ACCESS REPORT

PROJECT: PLC – Secondary Innovation Precinct (SIP) and Campus Commons
PROJECT NO: GDL240387.1
PREPARED FOR: Pymble Ladies College
REVISION: C
DATE: 27/05/2025

6.0 APPENDIX B – PLAN MARKUPS (SIP BUILDING).

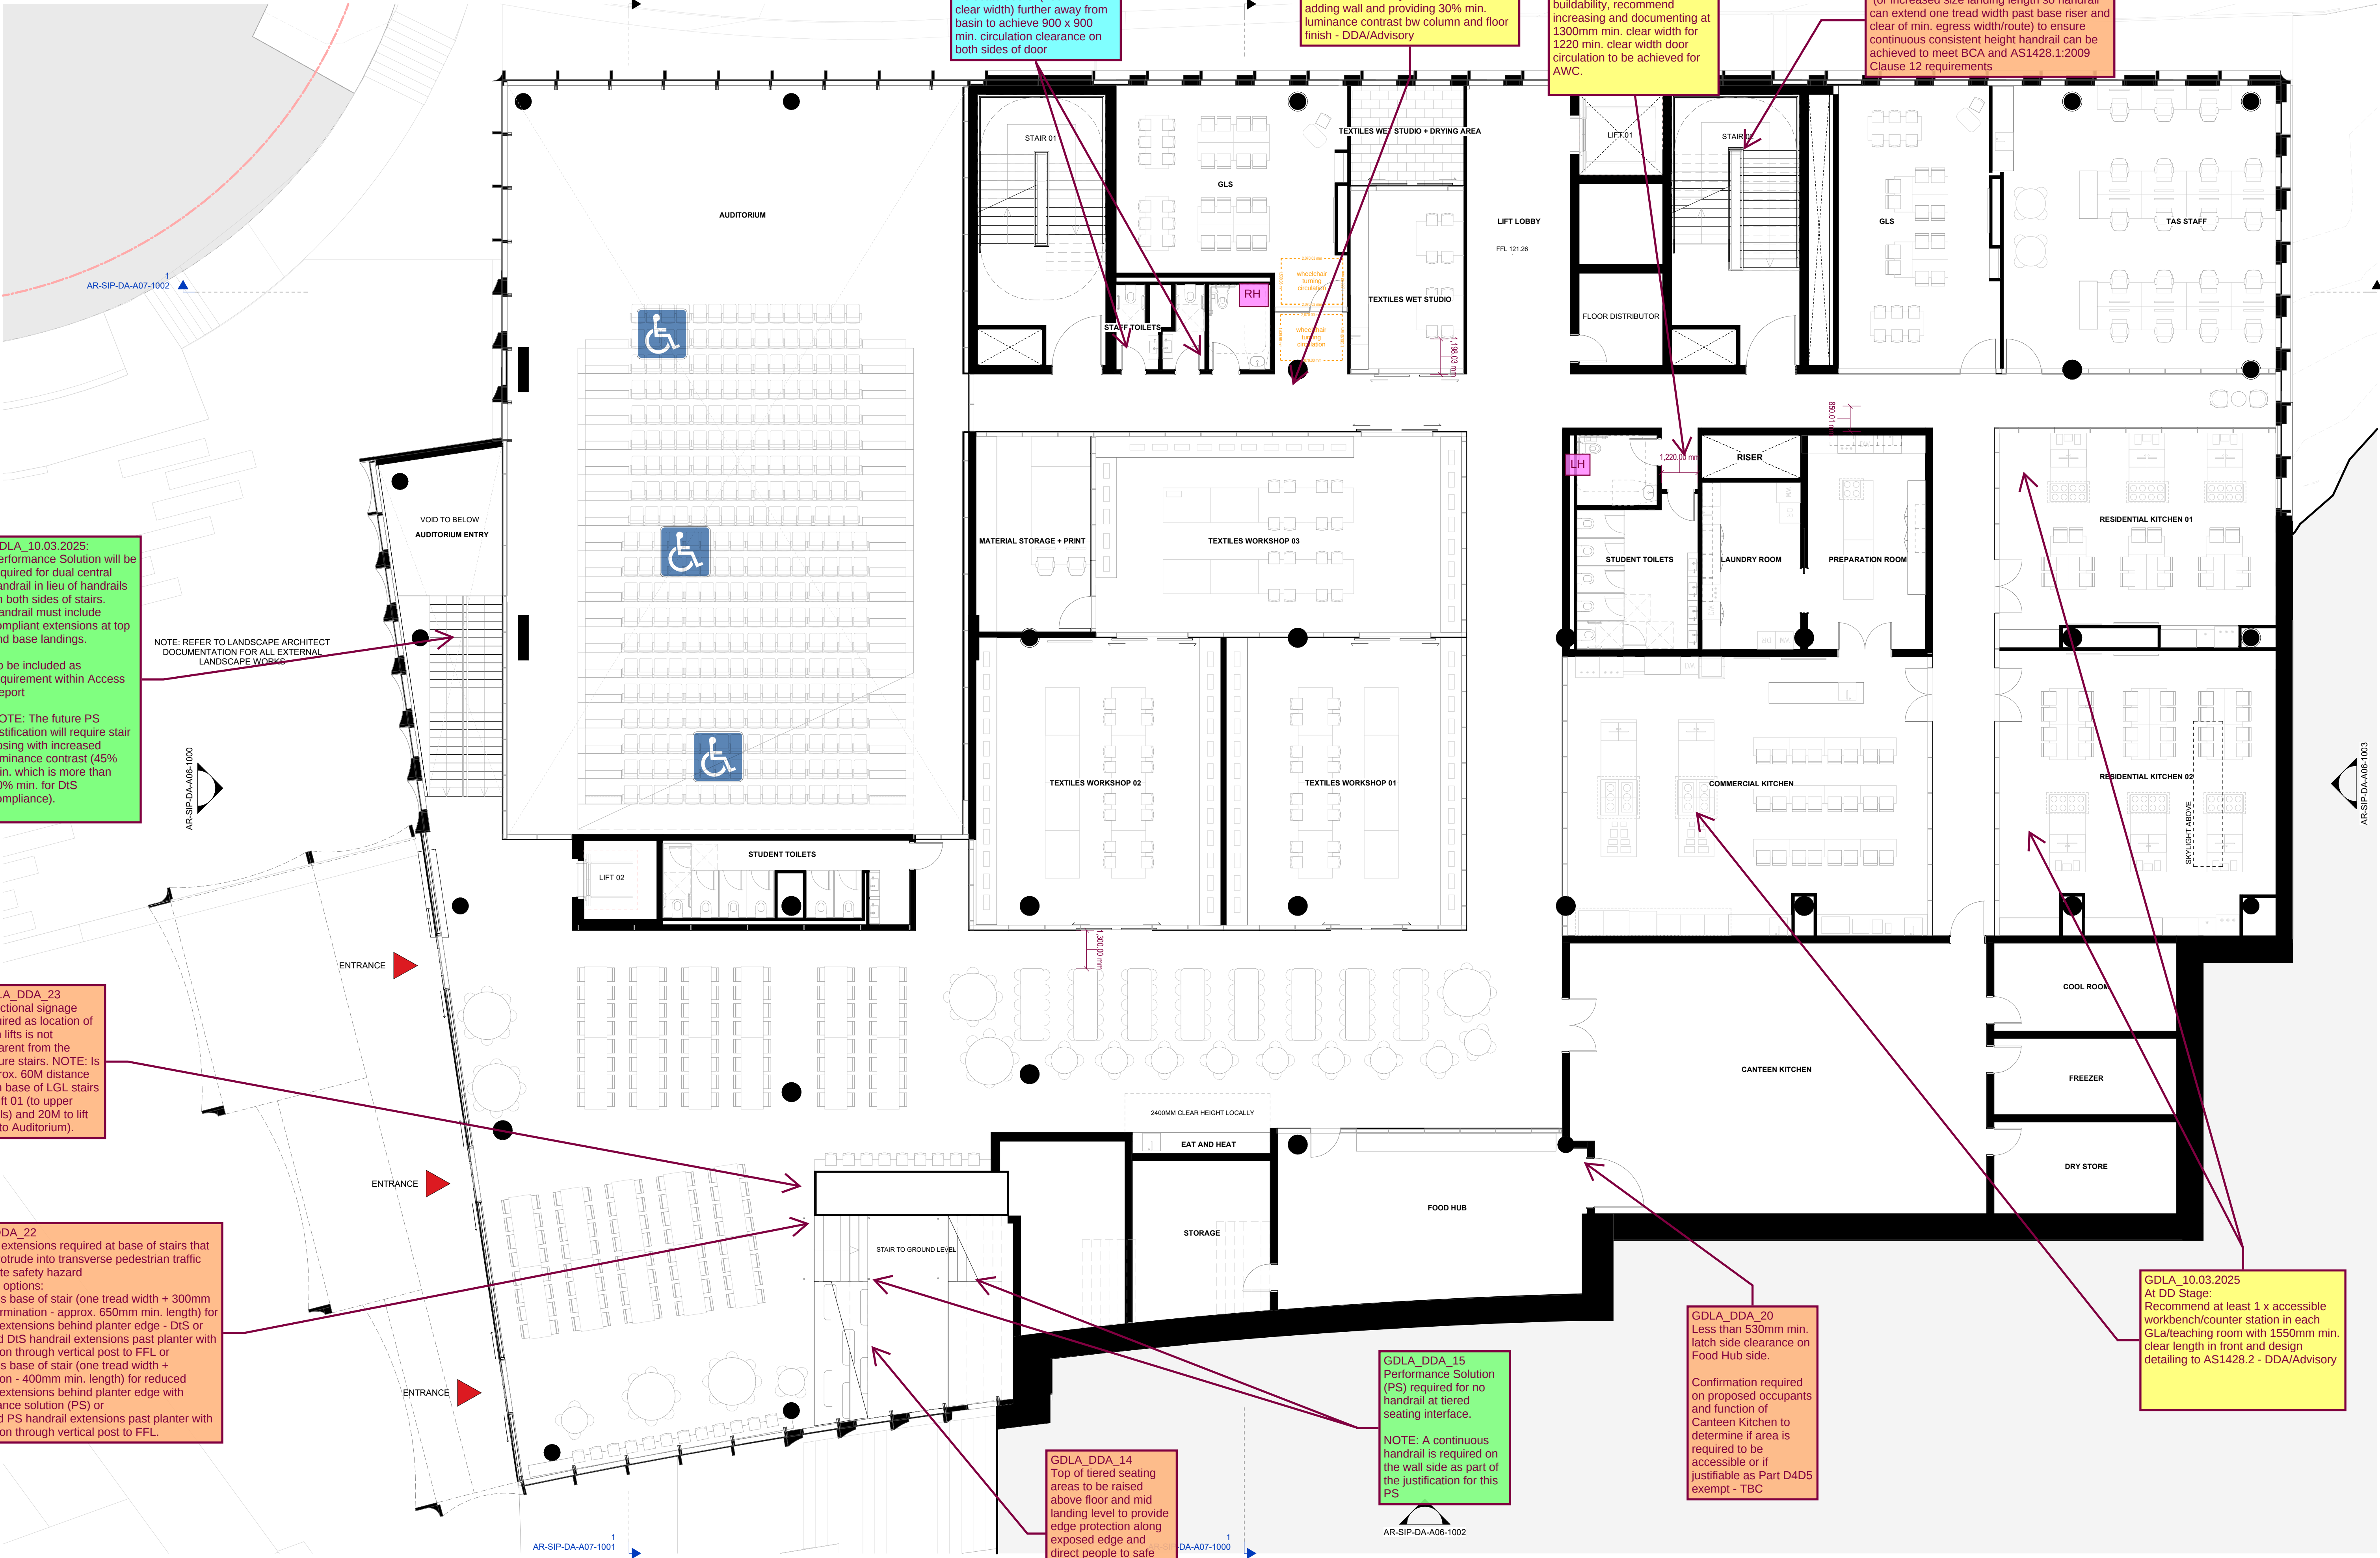
GDLA_10.03.2025:
Performance Solution will be required for dual central handrail in lieu of handrails on both sides of stairs.
Handrail must include compliant extensions at top and base landings.

GDLA_DDA_22
Handrail extensions required at base of stairs that do not protrude into transverse pedestrian traffic and create safety hazard
Potential options:
1. Recess base of stair (one tread width + 300mm min. + termination - approx. 650mm min. length) for handrail extensions behind planter edge - DiS or
2. Extend DiS handrail extensions past planter with termination through vertical post to FFL or
3. Recess base of stair (one tread width + termination - 400mm min. length) for reduced handrail extensions behind planter edge with Performance solution (PS) or
4. Extend PS handrail extensions past planter with termination through vertical post to FFL.

GDLA_21.03.2025
Provide off-set tread at base of each stair flight (or increased size landing length so handrail can extend one tread width past base riser and clear of min. egress width/route) to ensure continuous consistent height handrail can be achieved to meet BCA and AS1428.1:2009 Clause 12 requirements

GDLA_10.03.2025
At DD Stage:
Recommend at least 1 x accessible workbench/counter station in each GLa/teaching room with 1550mm min. clear length in front and design detailing to AS1428.2 - DDA/Advisory

GA PLAN - GROUND FLOOR

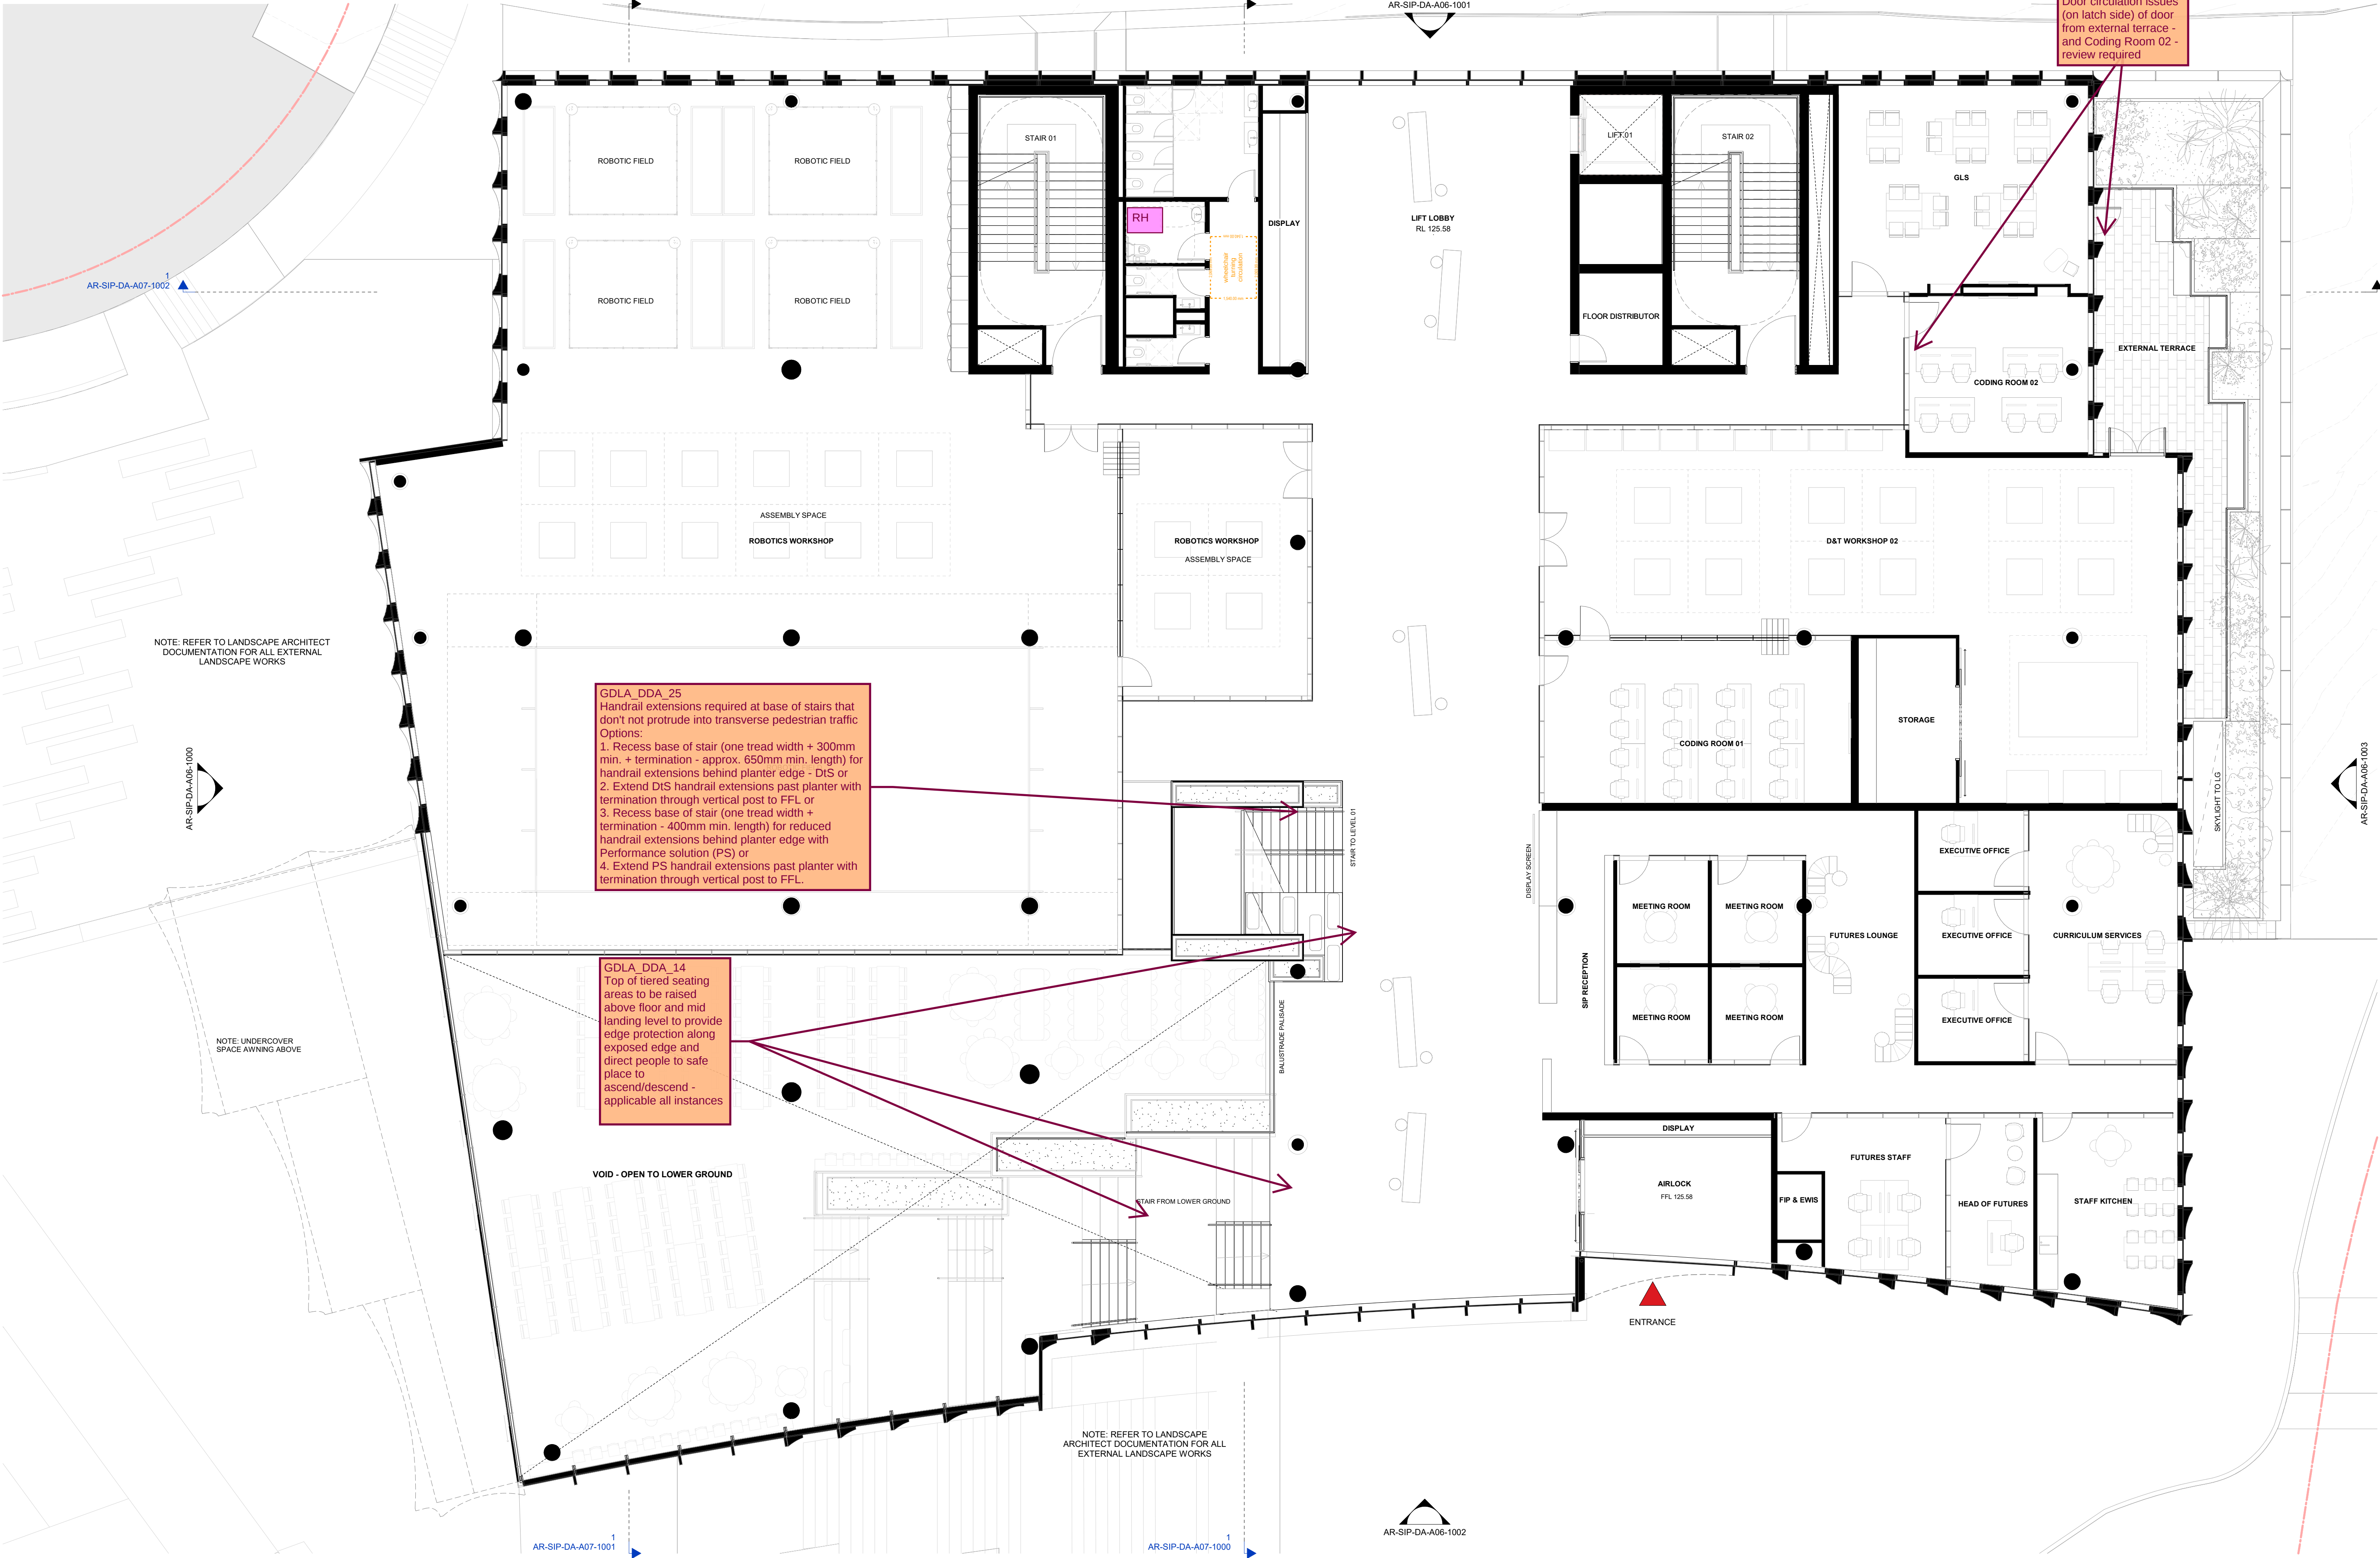
GDLA_DDA_15
Performance Solution (PS) required for no handrail at tiered seating interface.

NOTE: A continuous handrail is required on the wall side as part of the justification for this PS

GDLA_DDA_14
Top of tiered seating areas to be raised above floor and mid landing level to provide edge protection along exposed edge and direct people to safe place to ascend/descend - applicable all instances

GDLA_DDA_25
Handrail extensions required at base of stairs that
don't not protrude into transverse pedestrian traffic
Options:
1. Recess base of stair (one tread width + 300mm
min. + termination - approx. 650mm min. length) for
handrail extensions behind planter edge - DiS or
2. Extend DiS handrail extensions past planter with
termination through vertical post to FFL or
3. Recess base of stair (one tread width +
termination - 400mm min. length) for reduced
handrail extensions behind planter edge with
Performance solution (PS) or
4. Extend PS handrail extensions past planter with
termination through vertical post to FFL.

GDLA_DDA_14
Top of tiered seating
areas to be raised
above floor and mid
landing level to provide
edge protection along
exposed edge and
direct people to safe
place to
ascend/descend -
applicable all instances

GDLA_10.03.2025:
NOTE: Acceptable door circulation to for AWC for hinge side approach (1220mm min.), however there is minimal construction tolerance for buildability

It would be preferred to achieve 1550mm min. clear corridor width (for turning area 1540 W x 2070 L within 2m corridor end) but we can support it as shown given the toilet only leads to ambulant toilets (that are not required to be accessible for wheelchair users).
